## ADDENDUM NO. 02

Date of Issuance: January 24, 2025

Project: **2024 Cypress Falls HS Renovation**  
Cypress-Fairbanks Independent School District

Texas Arcadis Inc.  
Project No.: 202318

1 AREA 'G1' - 1ST FLOOR FINISH PLAN  
 1/8" = 1'-0"

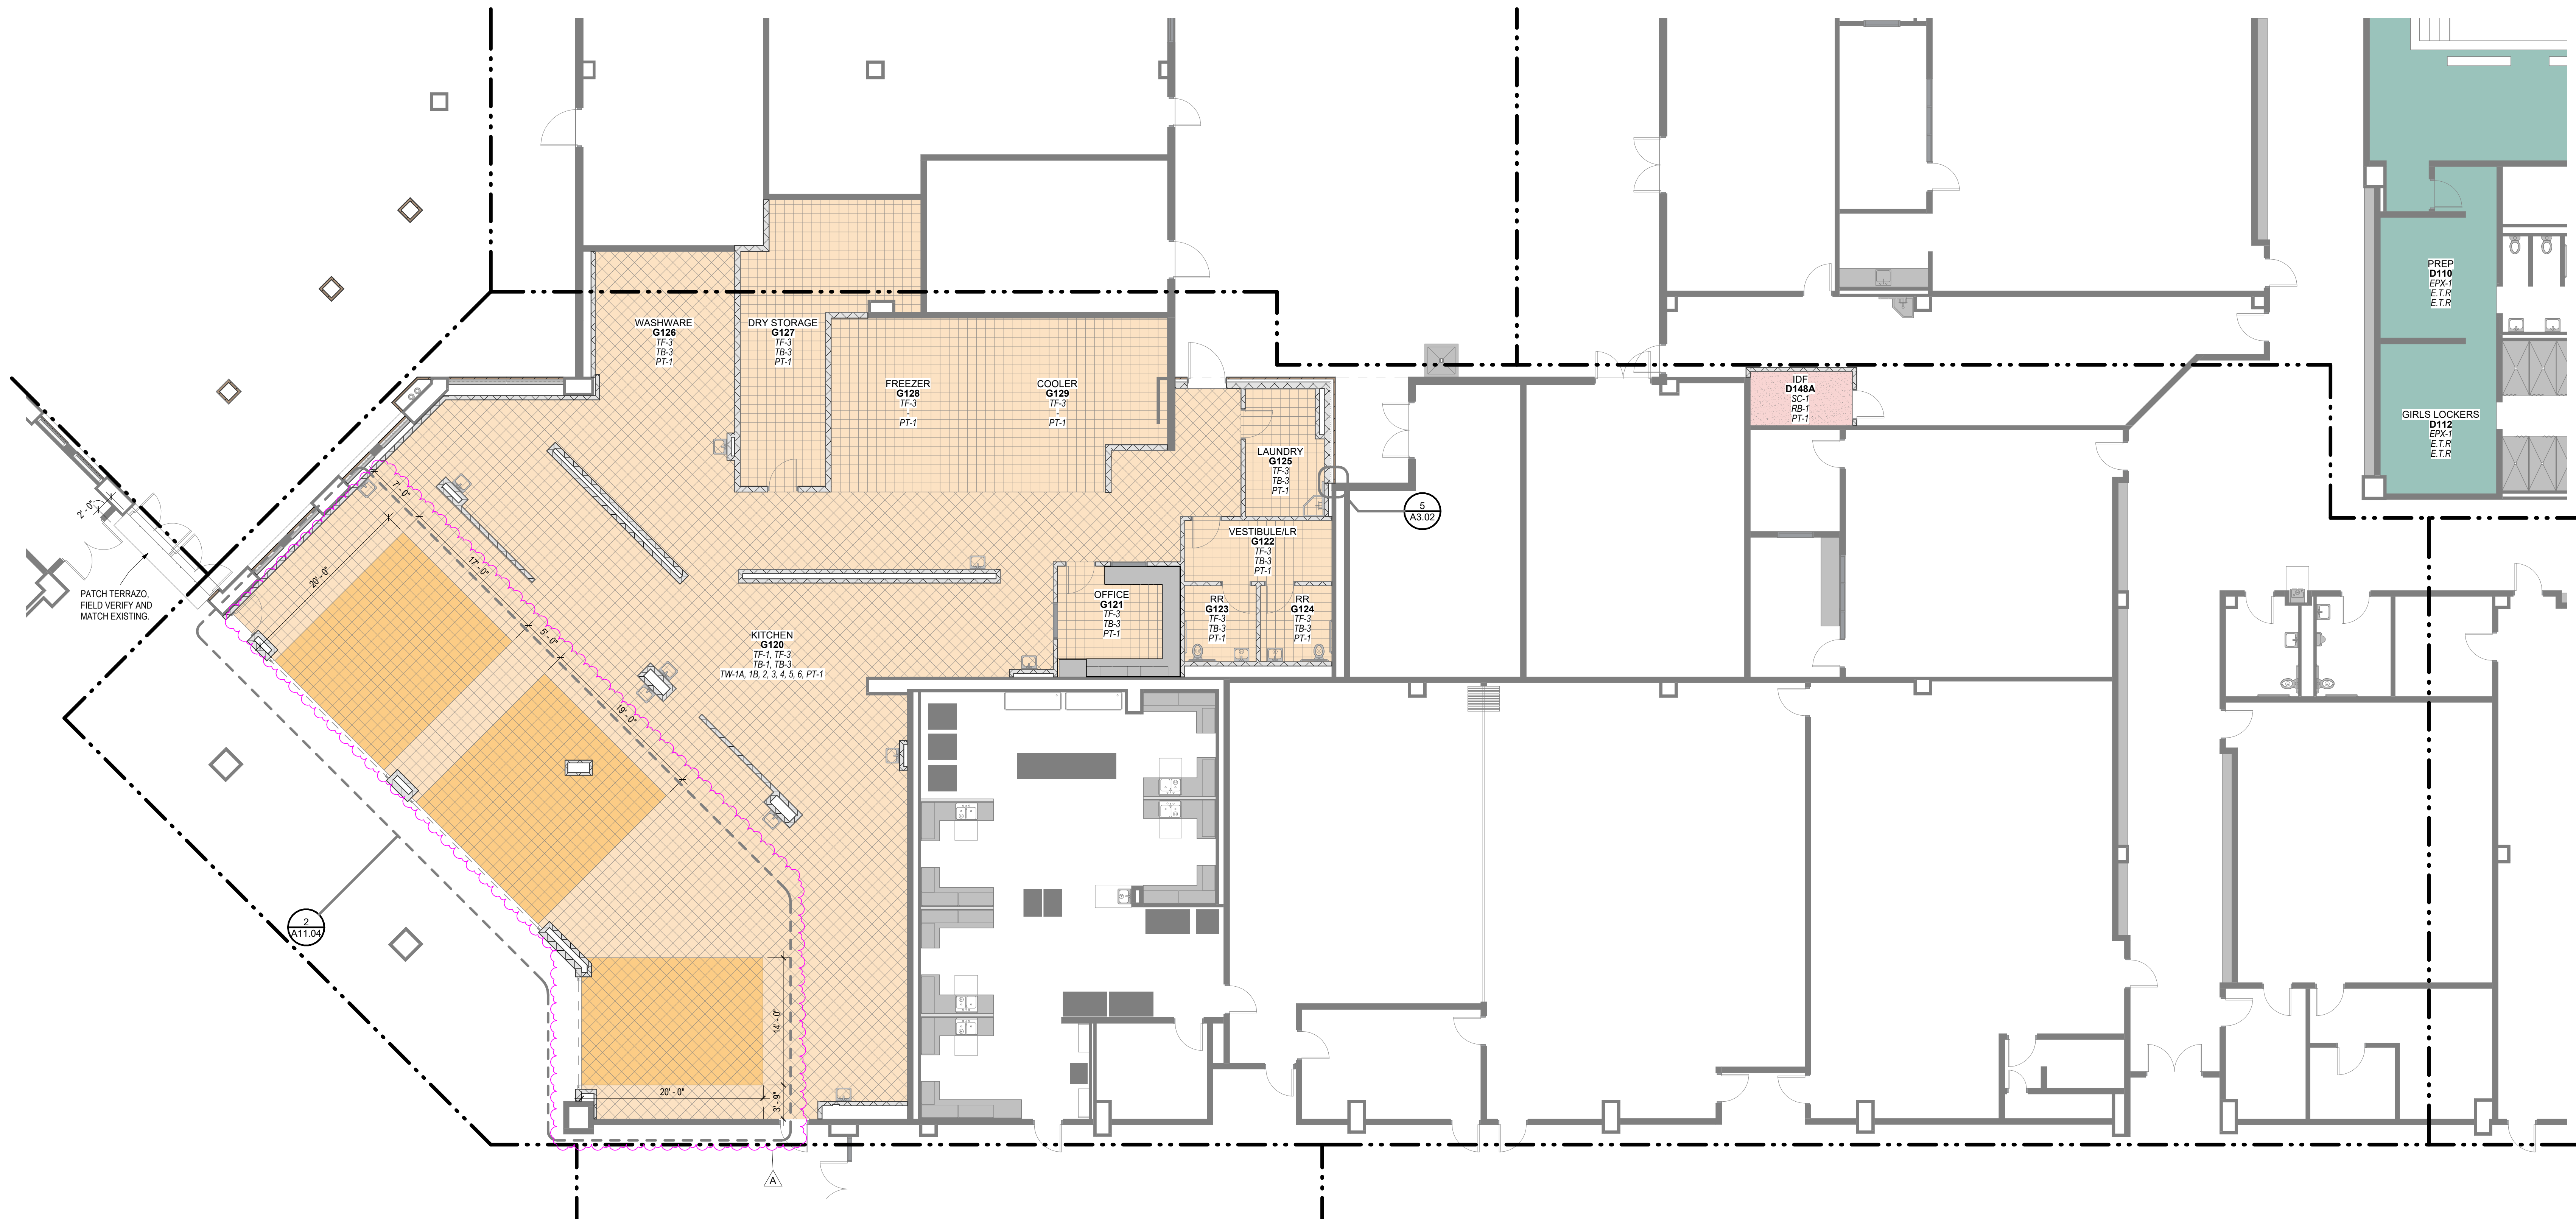
55. Sheet A11.00 – INTERIOR FINISH LEGEND
- a. Added new PL-3.
  - b. Shifted TW-1A – TW-6 to new column, added TW-7.
56. Sheet A11.04 - AREA ‘G’ 1<sup>ST</sup> FLOOR PLAN FINISH PLAN
